ADDENDUM No. 3
Request for Competitive Sealed Proposals (CSP)
19CSP067 HVAC and Electrical Improvements at Hill
Elementary School

ADDENDUM NUMBER 3

Project: **HVAC and Electrical Upgrades at
Hill Elementary School
Austin Independent School District
PROJECT NO. 19CSP067 (19-0021-HILL)**

SHEET TITLE: BUILDING B ELECTRICAL DEMOLITION AND NEW LIGHTING PLAN
DATE: 11/02/18 PROJECT NO. 99091
REVISION: ADDENDUM #3 11-29-18
SHEET NO. E101

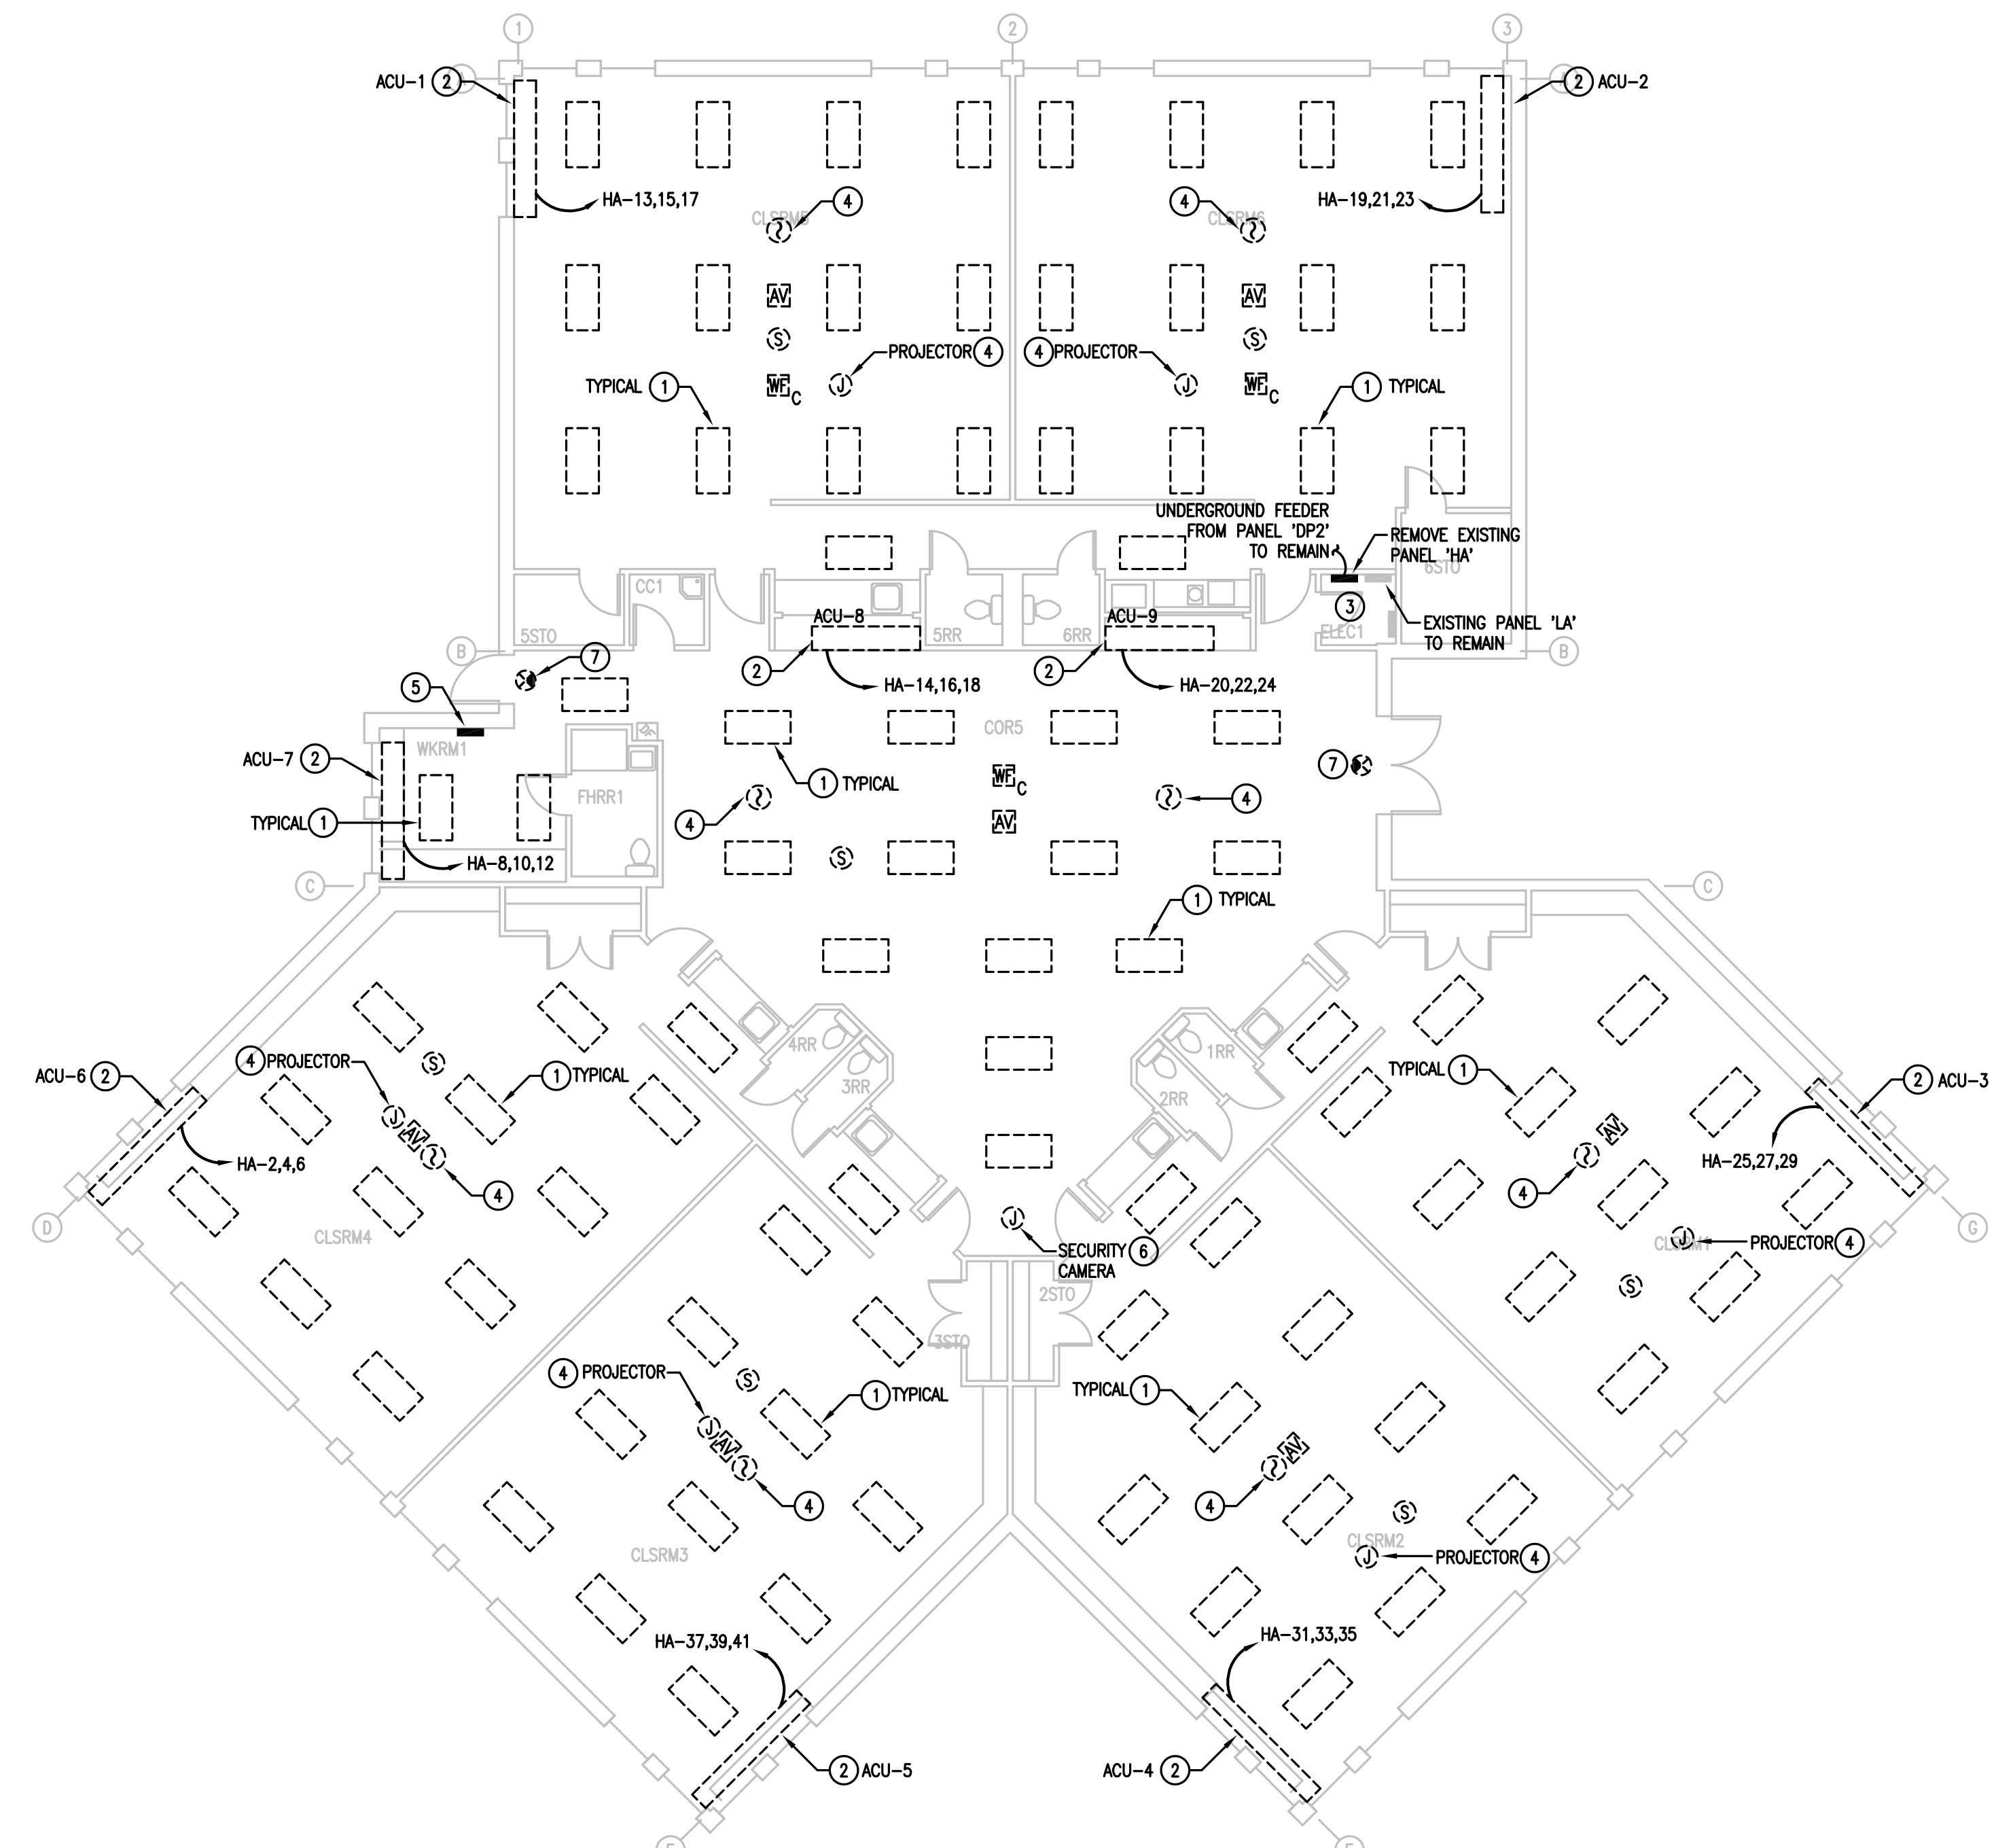
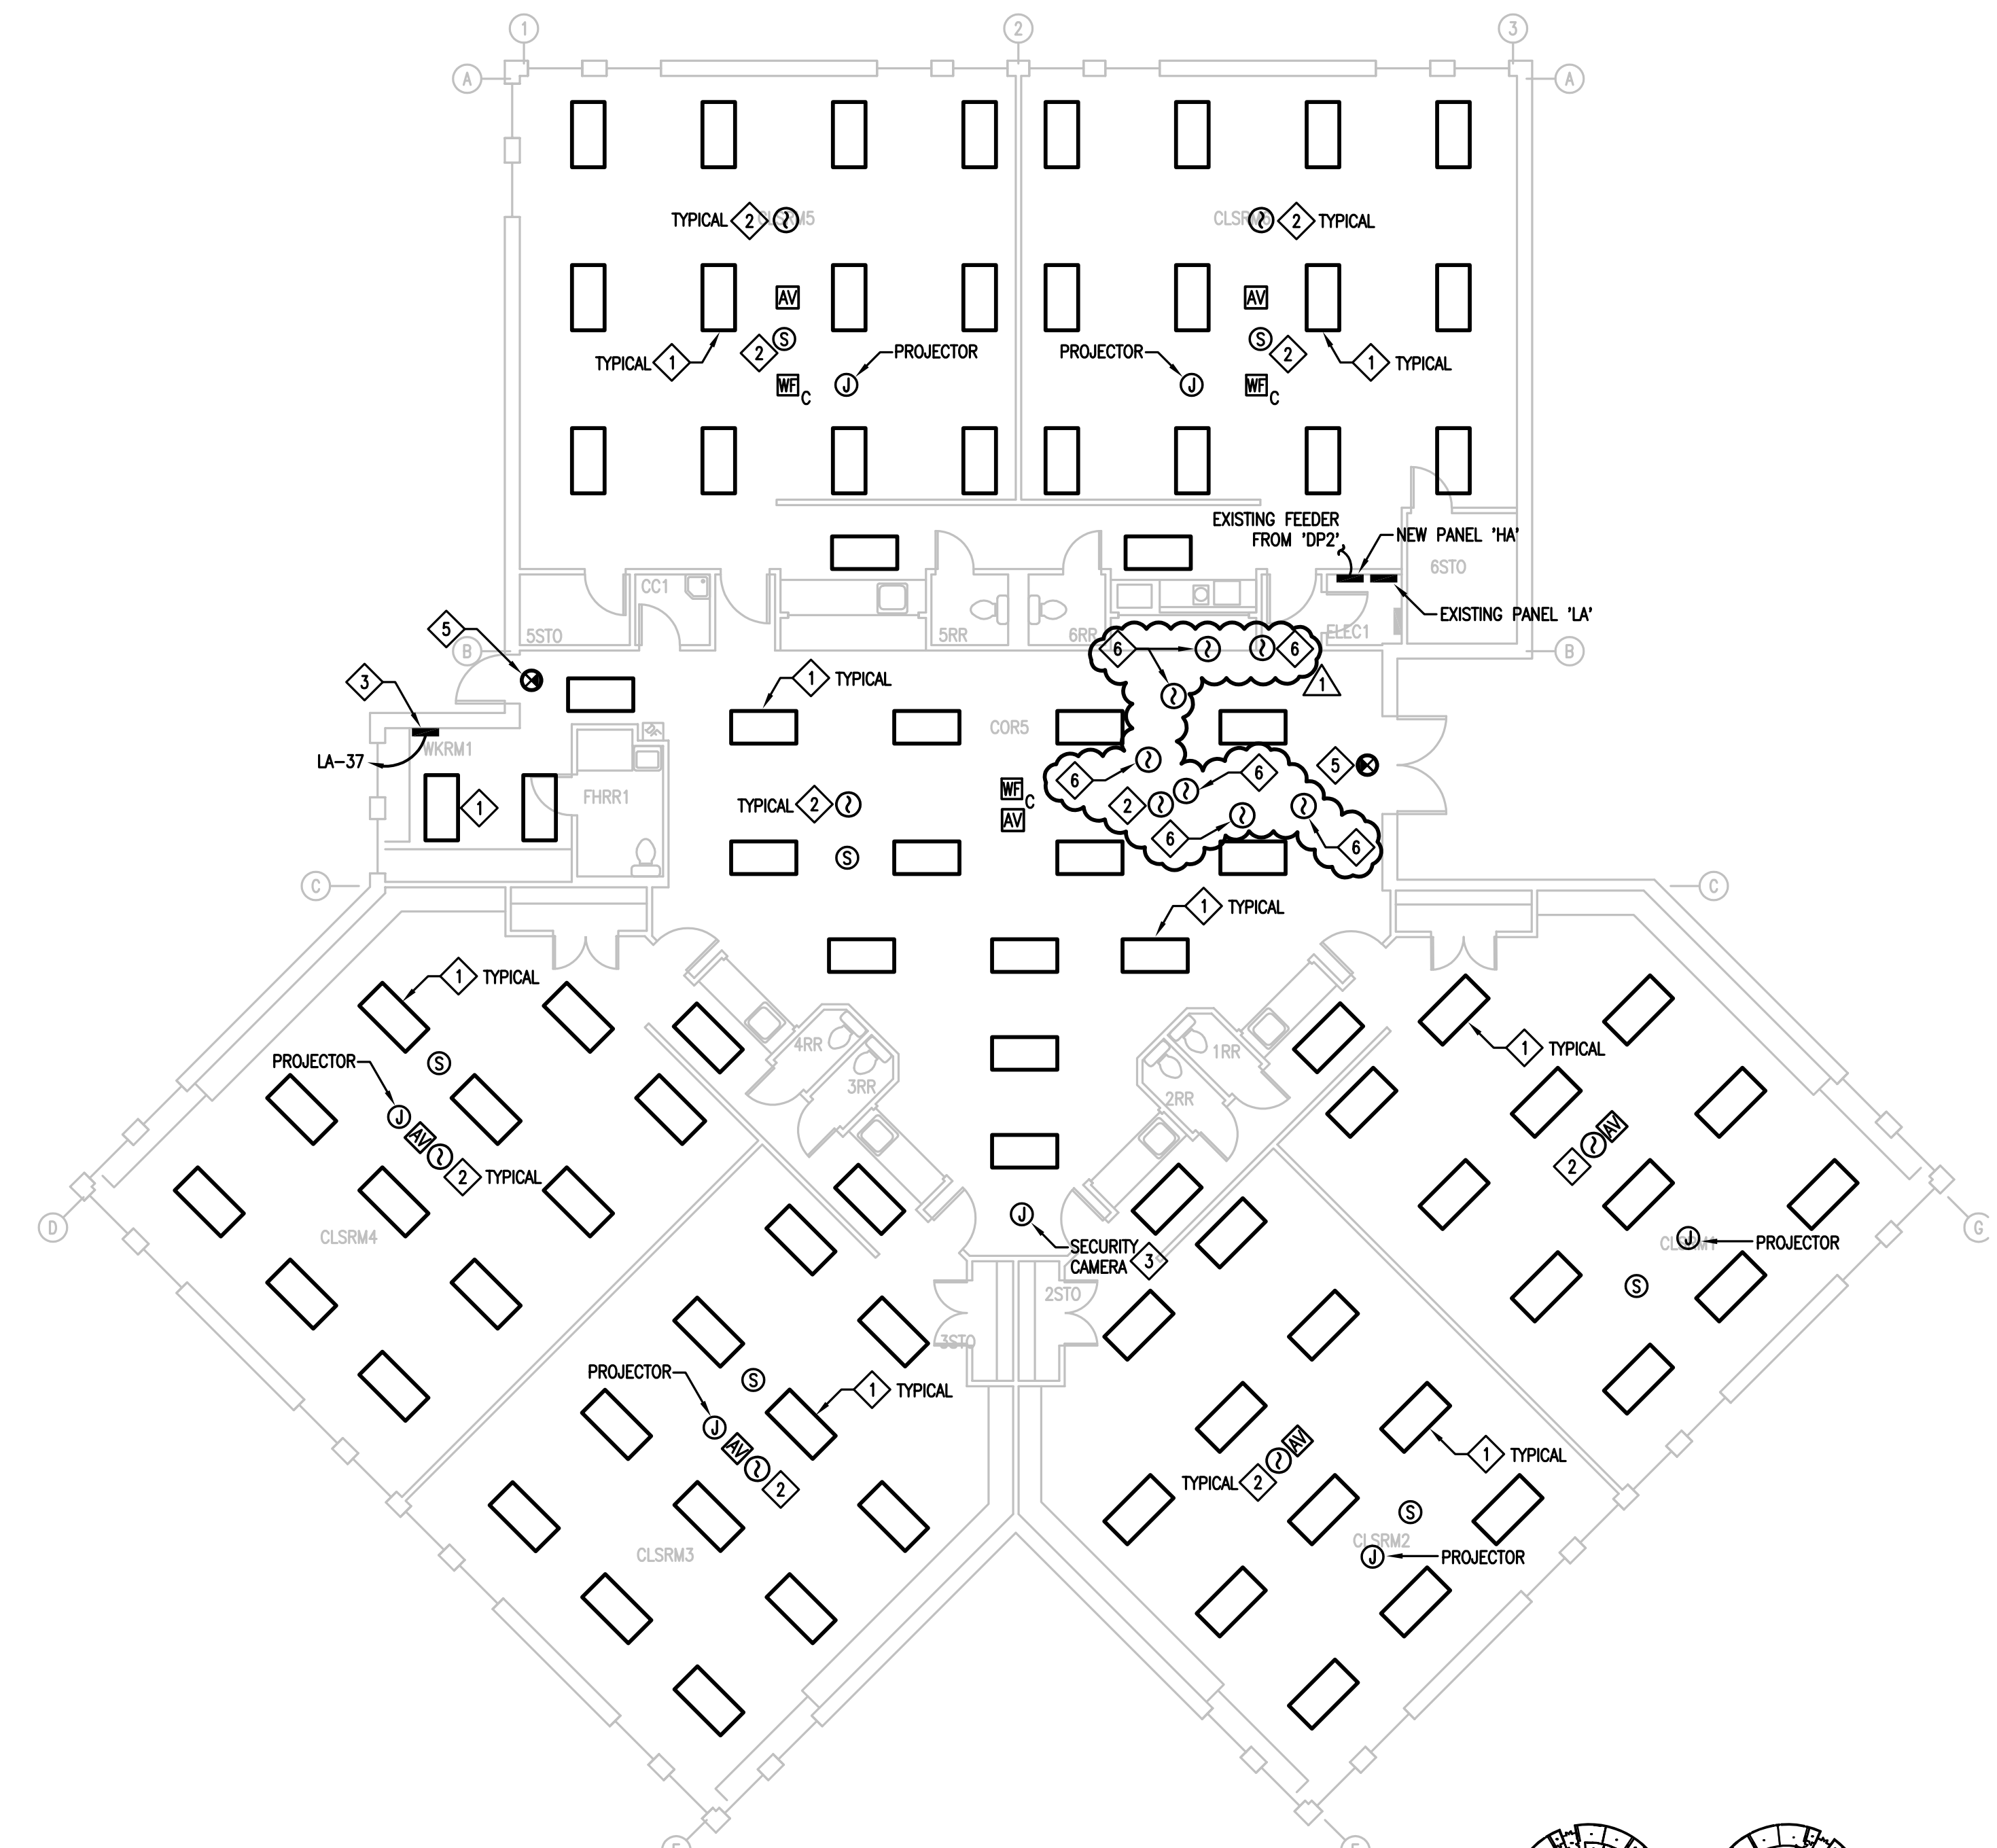
Sheet E101 – Floor Plan Electrical

- a. Add supply duct detectors as indicated.

Response: The detector will be removed from the return and added to supply side for each zone. Refer to attached drawings M301 and E101.

Response: A total of (7) detectors shall be installed. Refer to attached drawings M301 and E101.

- 1 REINSTALL EXISTING 2x4 LIGHTING FIXTURES WITH NEW 3-F32 4000K LAMPS.
- 2 REINSTALL EXISTING INTERCOM SPEAKER, SMOKE DETECTOR, AUDIO/VISUAL FIRE ALARM, WIRELESS NETWORK DEVICE, AND PROJECTOR IN NEW CEILING OF EACH CLASSROOM AND CORRIDOR.
- 3 CONNECT NEW HVAC CONTROL PANEL TO EXISTING 120V CIRCUIT.
- 4 REINSTALL EXISTING SECURITY CAMERA IN NEW CEILING.
- 5 REINSTALL EXISTING EXIT LIGHTING IN NEW CEILING.
- 6 PROVIDE REMOTE TEST DEVICE IN CEILING DIRECTLY BELOW EACH DUCT DETECTOR.
